CURRENT  
EMERGENCY PLAN  
IMPLEMENTING PROCEDURES  
TABLE OF CONTENTS  
Volume 3A

# PROCEDURE ON-THE-SPOT CHANGE

Procedure No. EP OP-11 Rev. 3 Unit No. 1  2  1 & 2   
Title Loss of Component Cooling Water

# DIABLO CANYON POWER PLANT PROCEDURE ON-THE-SPOT CHANGE

FIGURE 2

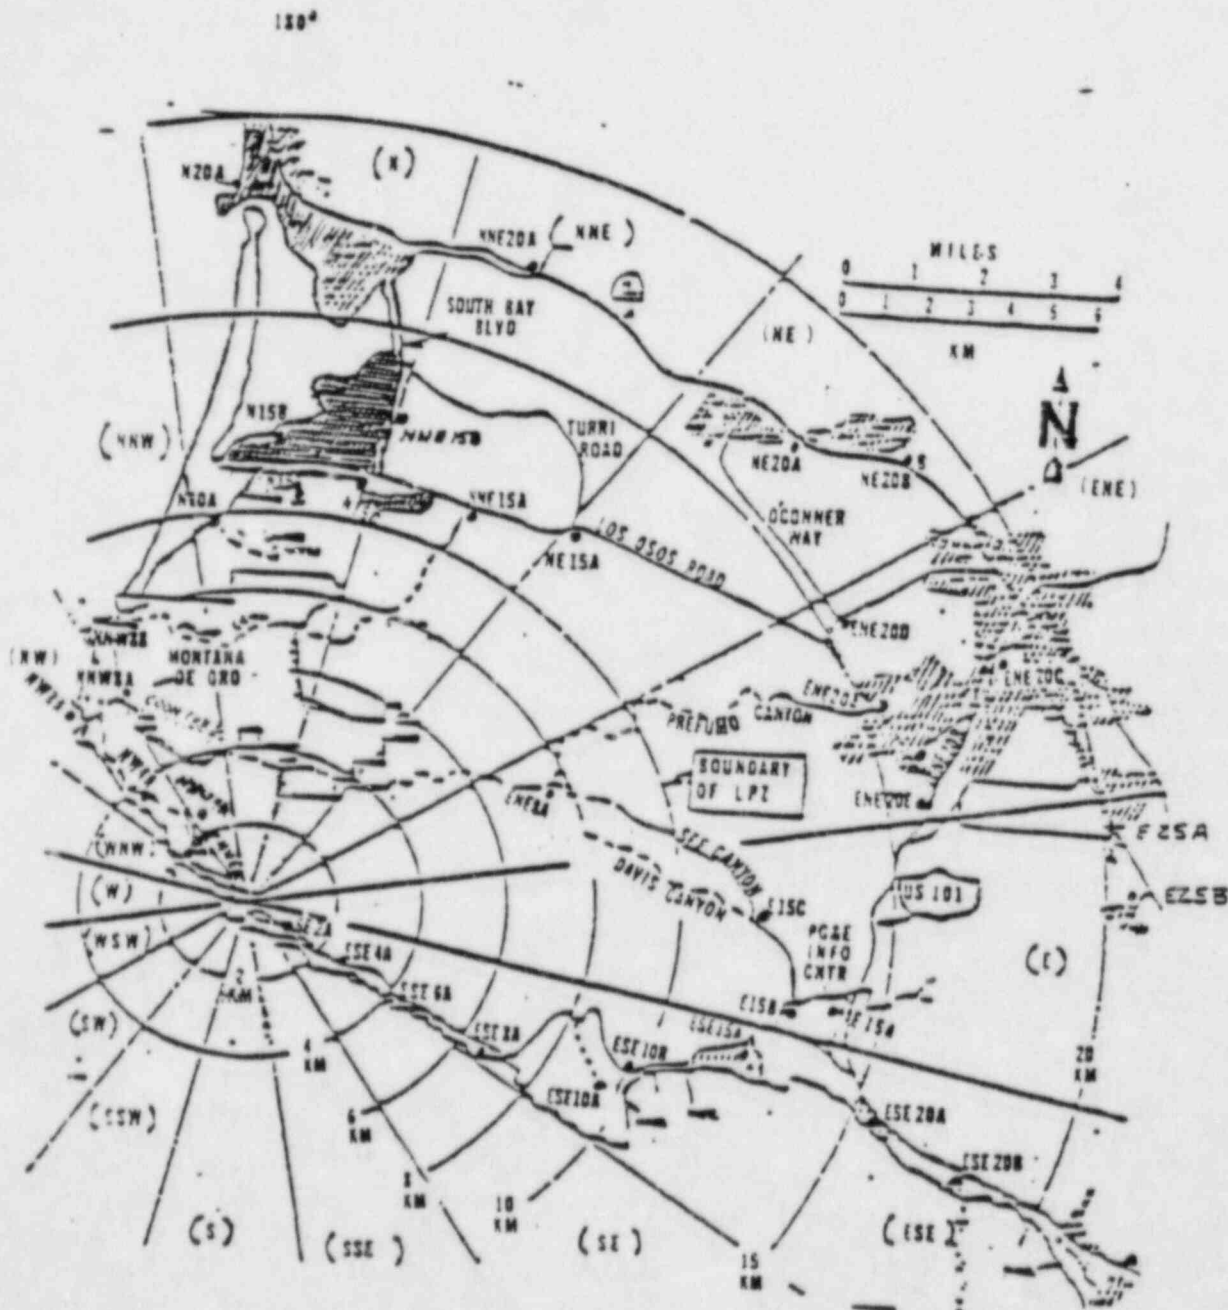
Use attached Figure 2, dated 8/8/83, in place of Figure 2, dated 7/10/83,  
on page 27 of procedure.

To provide a updated diagram
